**COMMENTS AND OBSERVATIONS
ON THE DRILLING ACTIVITIES PERFORMED BY
EPA's TAT CONTRACTOR
AND SUBCONTRACTED DRILLER
DURING THE PERIOD OF
JUNE 23 THROUGH JUNE 27, 1992**

**UNITED PARK CITY MINES COMPANY
309 KEARNS BUILDING
SALT LAKE CITY, UTAH 84101**

**PIONEER TECHNICAL SERVICES, INC.
P. O. BOX 3445
BUTTE, MONTANA 59702**

JULY 13, 1992

FIGURE 1
WELL AND LANDFILL
LOCATION MAP

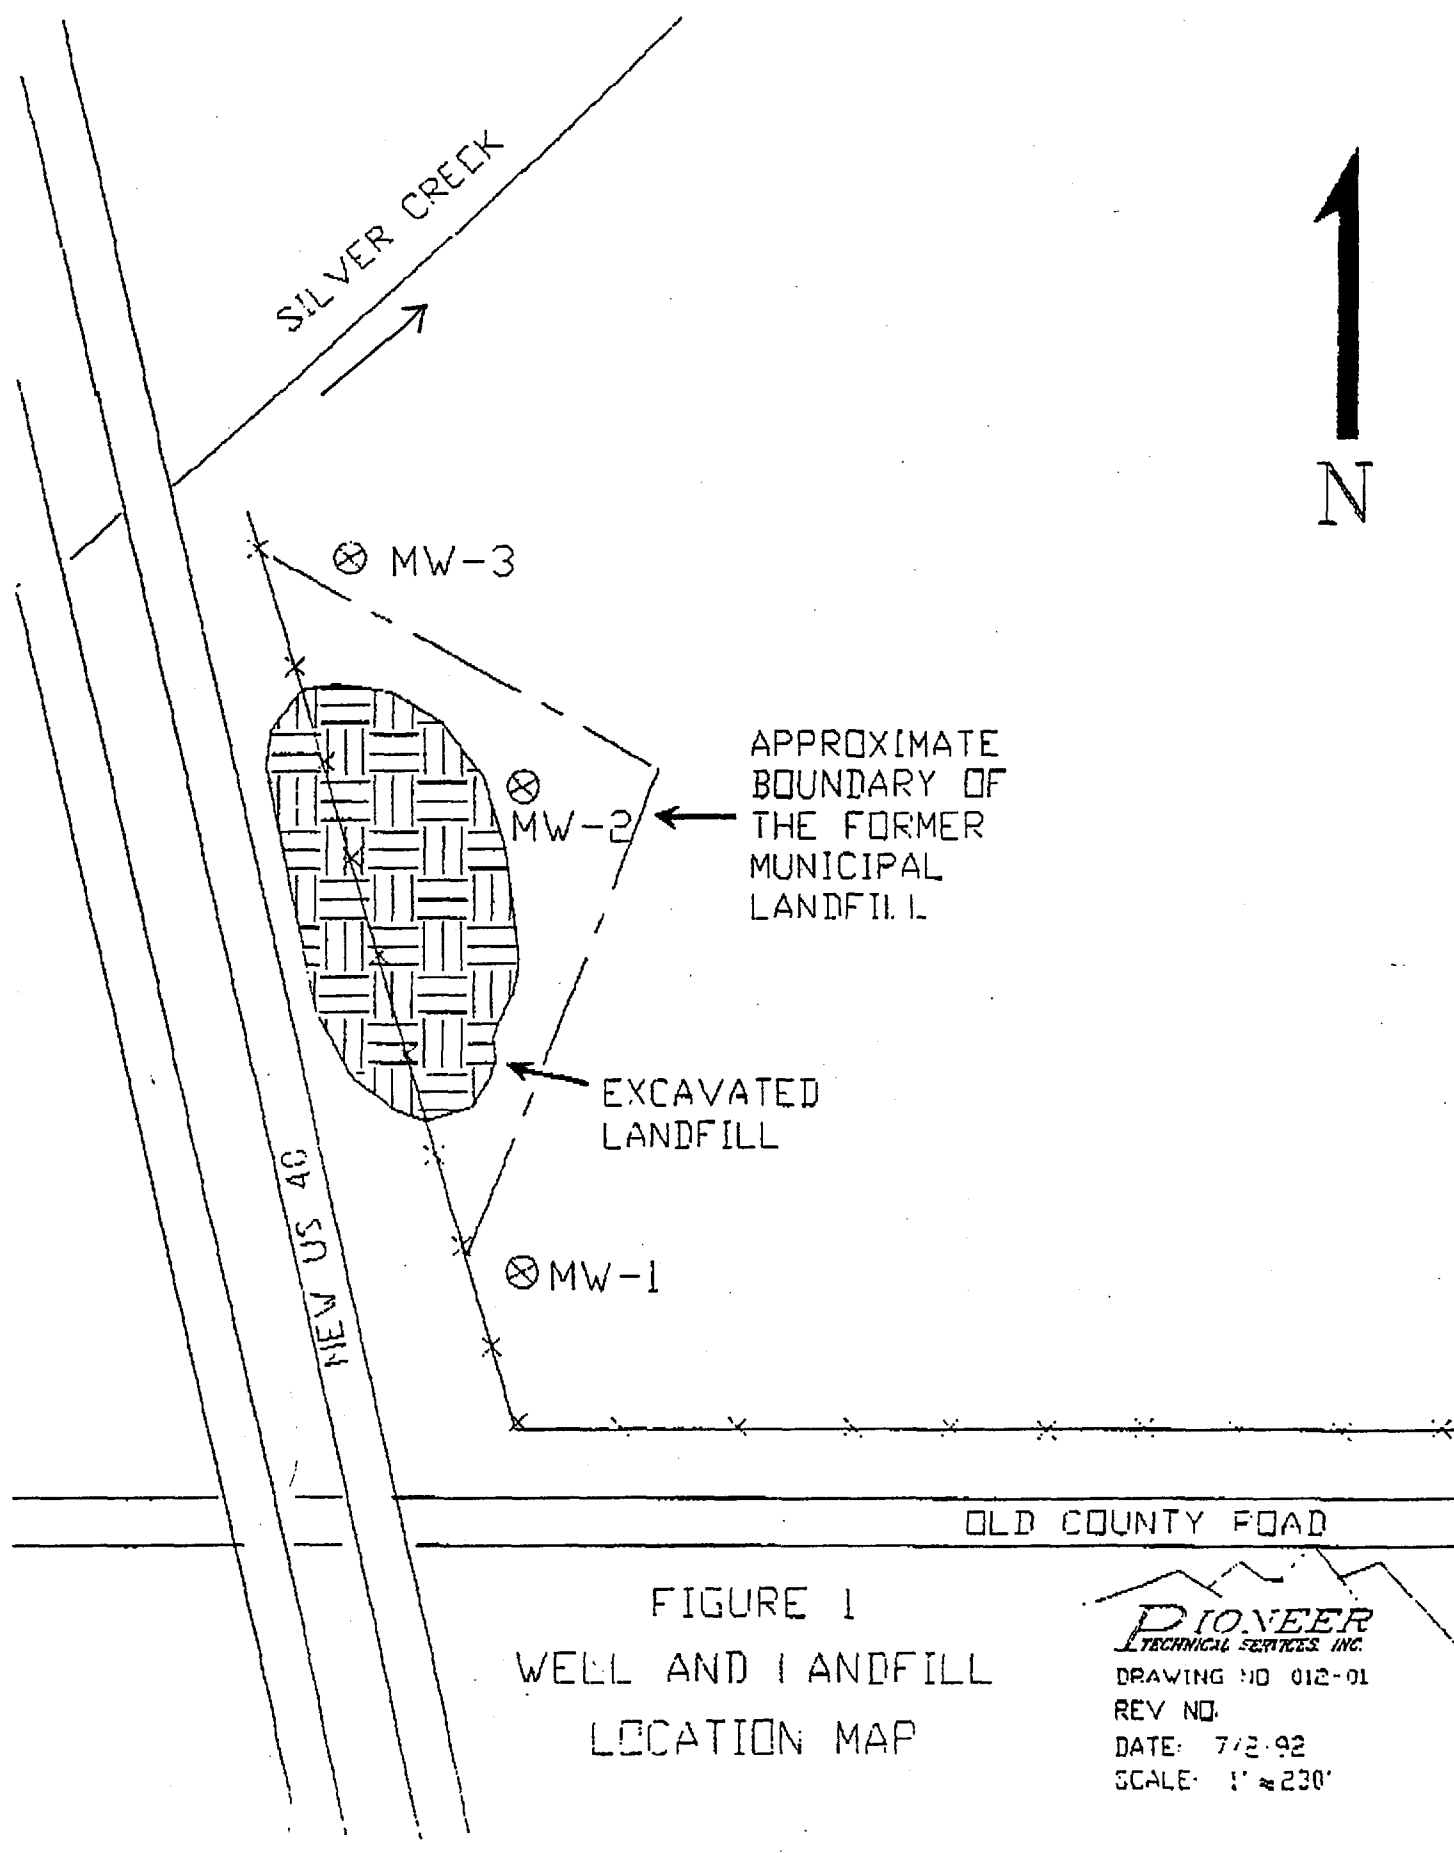
The most blatant violation of EPA guidance in the drilling of these monitoring wells was the placement of well MW-2 within the boundary of the historic landfill (see Figure 1). USEPA direction is clear - drilling directly through municipal landfills is to be avoided in order to protect underlying groundwater, and for obvious safety considerations; rather, drilling is to be conducted off of the actual landfill and downgradient from it. Prior to drilling, the TAT was advised by the property owner (UPCM) that the location selected for MW-2 was within the former landfill boundary. For whatever reasons, the TAT declined to relocate the well 100 feet to the north, out of the former landfill. After drilling five to ten feet, drill cuttings and split-spoon sample cores showed that the borehole was obviously within the landfill. ?

At this point, the proper procedure would have been to properly abandon the borehole, move off the landfill, and drill a new borehole in a safer location; however, the TAT persisted with drilling in the landfill. If TAT had adequate training and experience in hydrogeology, they would have anticipated the potential for problems arising from drilling through a landfill, and chosen to drill elsewhere. TAT's lack of experience and refusal to follow USEPA policy resulted in one of the most serious monitoring well installation calamities possible (described below). ?

FIGURE 2
GEOLOGIC CROSS SECTION
AND LANDFILL MONITORING WELLS

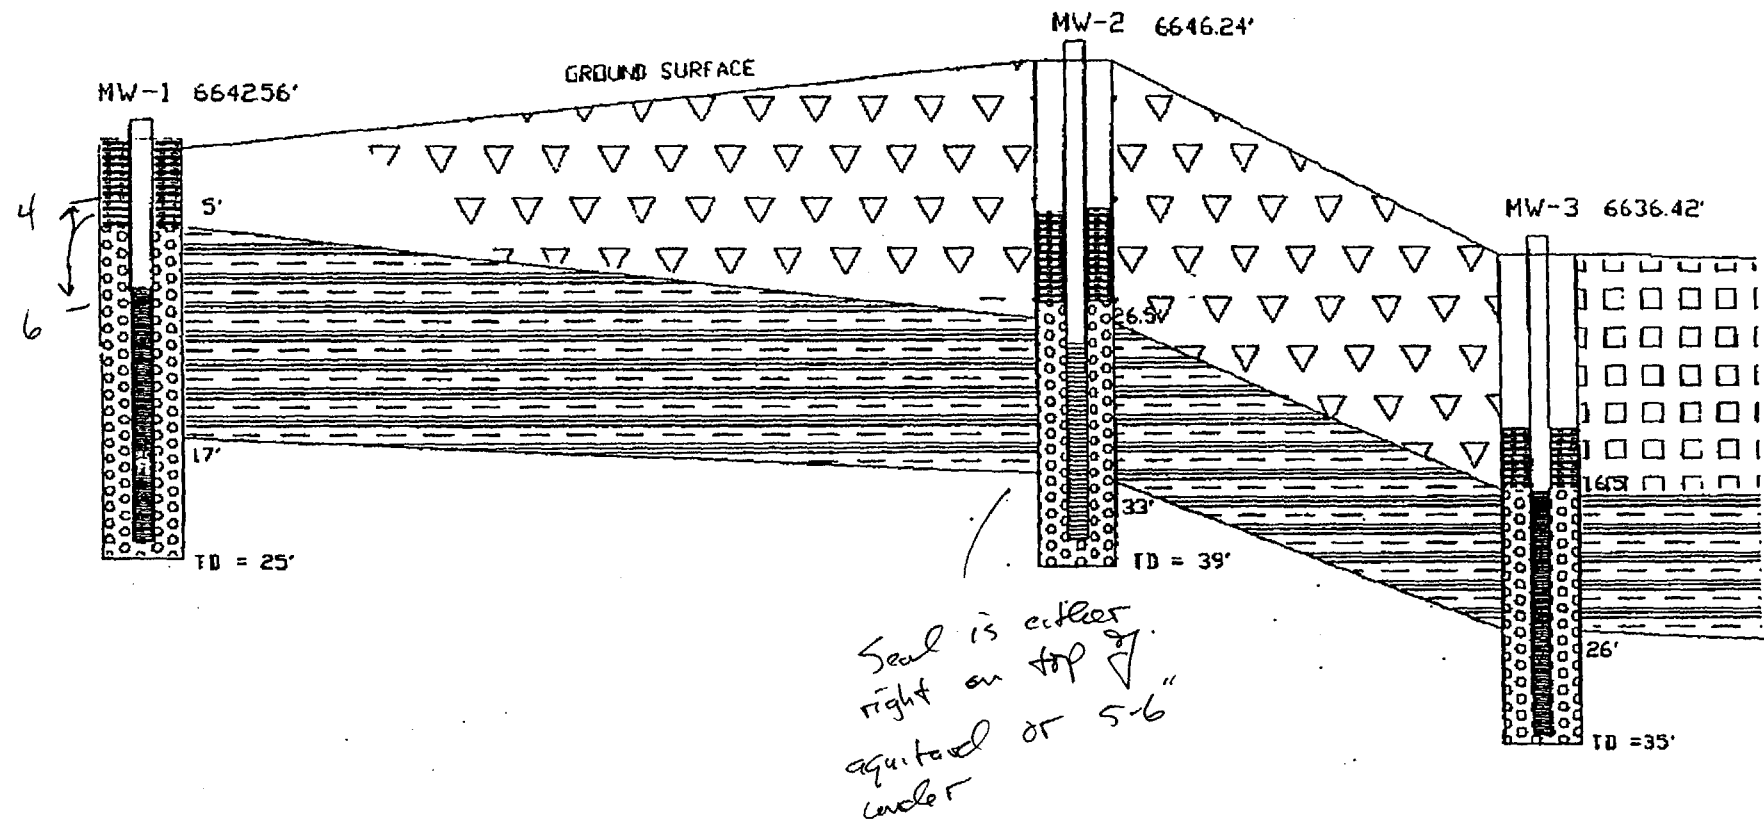
This is the most egregious violation of sound hydrogeologic practice and may have violated State of Utah regulations for monitoring wells, water wells, or groundwater protection. The drilling of all three monitoring wells showed that the underlying groundwater was a confined or semi-confined aquifer system. In each borehole, the saturated zones were found beneath a thick, apparently continuous aquitard that isolated the landfill materials from underlying groundwater system (see cross-section, Figure 2). In each of the three monitoring wells, the static water level rose to an elevation significantly higher than the level at which water was first encountered. ?

Borehole MW-1 (upgradient) first encountered this aquitard at 5 feet below ground surface (bgs) and the first groundwater at 16 to 18 feet below the surface (the base of the aquitard). The

borehole was deepened to 25 ft bgs and the well was completed; however, rather than installing 10 feet of screen to 15 ft bgs (near the first water), TAT put in 15 feet of screen, possibly interconnecting several discrete saturated zones. The following day, the water level had risen to only 8 feet bgs, clearly indicating that the underlying groundwater was under pressure.

After ill-advisedly locating well MW-2 within the former landfill (discussed above), drilling commenced. For whatever reason, the TAT did not closely monitor the drill cuttings from the borehole; however, UPCM's hydrogeologist was because of the geology observed at MW-1 and concern about breaching the aquitard underlying the landfill. At 25 ft bgs, a two-foot split spoon core revealed six inches of the aquitard (a reddish-brown clay) in the bottom of the core barrel, clearly showing the top of the aquitard to be at 26.5 ft bgs. The TAT erroneously recorded the top of this unit at 25 ft bgs. Drilling continued (slowly) and water was encountered between 34 and 35 ft bgs. The drilling was halted at 39 ft bgs and well completion activities began.

At this point, serious errors in judgment and perhaps criminal negligence, caused the completion of well MW-2 to be entirely inappropriate, if not illegal. First, 10 feet of screen were placed in the well, bringing the screened section up to 27.5 ft bgs, very close to the top of the aquitard unit. Then, the filter pack was brought up to 26 ft bgs, above the aquitard. The bentonite seal placed on top of the sand was intended to plug the aquitard; however, due to careless geologic logging, it completely missed the aquitard and provides no such seal. The formerly continuous barrier between the landfill materials and groundwater has been breached by the drilling and not repaired during well construction. Water level measurements on subsequent days show clearly that the underlying water is under pressure and has risen up the borehole to exactly 26.5 ft bgs, the top of the aquitard. The underlying groundwater is now flowing up the well under pressure, out through the filter pack along the top of the clay aquitard and into the base of the formerly dry landfill. When this water discharges from the base of the landfill, either as springs or to Silver Creek, it will be contaminated by whatever is in the landfill.

Prior to the installation of well MW-2, the landfill was isolated from the groundwater system. EPA and their TAT contractor have breached this natural compacted clay barrier and are thus solely responsible for the ensuing potential groundwater and surface water contamination.

The third well, MW-3, was moved further north at the urging of UPCM. During drilling, construction debris was encountered, but no municipal landfill wastes. This well encountered the same hydrogeology and was similarly misconstructured; however, the results are not as critical. The same aquitard (reddish-brown clay) was encountered in MW-3 at 16.5 ft through 26 ft bgs and water was again encountered beneath it. Instead of completing the well with the screened section at 26 to 34 ft bgs, TAT decided to place 15 feet of screen in this well, 5 feet into the aquitard. Filter pack was again placed in the borehole up to the top of the aquitard (16.5 ft bgs), and the bentonite seal above that, again missing the aquitard and not sealing the borehole. The result of this is again, the upward migration of formerly confined groundwater into the construction debris and eventually out of the filled area to surface water.

- secondly, careful geologic logging would have shown the aquitard unit to be between 26.5 and 33 feet bgs, and hence, no need to screen above 33 ft bgs; and,
- finally, the placement of screen and sand up to the base of the aquitard (33-38 ft bgs) and bentonite within the aquitard (26-33 ft bgs) could have maintained the integrity of the natural barrier between the landfill materials and the underlying groundwater system.

In any event, the serious nature of the well construction disaster described above is at least unprofessional and at worst illegal. I recommend that all of these wells be properly abandoned as soon as possible. It is especially critical that MW-2 be plugged so that it does not continue to flood the landfill.
